Northern Beaches Health Service Redevelopment
A new wave in healthcare

Northern Beaches Hospital SSI Application SSI 13_5982

Submissions Report/Preferred Infrastructure Report

February 2014

Figure 1 Noise assessment design for site clearing and preparatory works

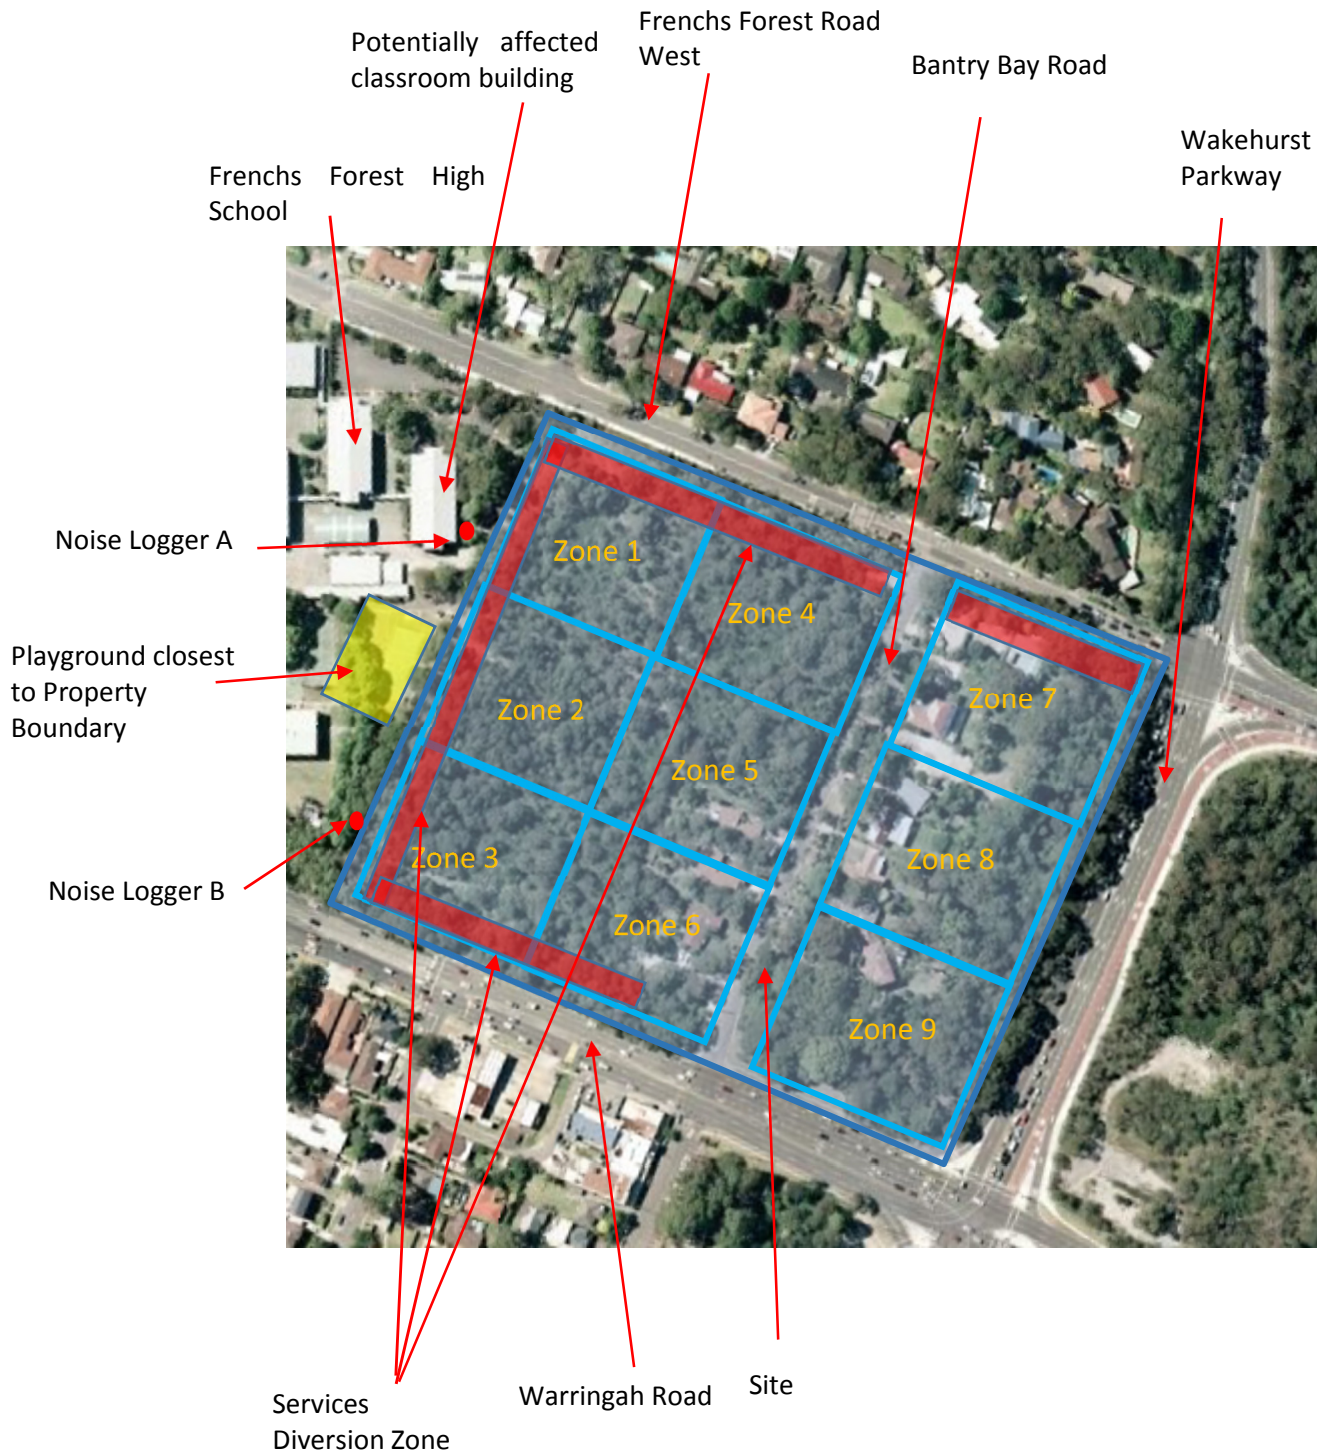
29. Reference to Zone 7 twice in figure on page 5 of Appendix K.	<p>This is a typographical error. The three zones on the eastern part of the site should read (north to south): 'Zone 7', 'Zone 8', 'Zone 9'. This does not have any bearing on the outcomes of the analysis.</p> <p>The corrected figure is provided in Section 3.3 of this report.</p>

There was also a minor labelling error with Figure 1 in the noise assessment report with regard to the numbering of the nine management zones on the hospital site. The corrected Figure 1 is also shown on the following page.
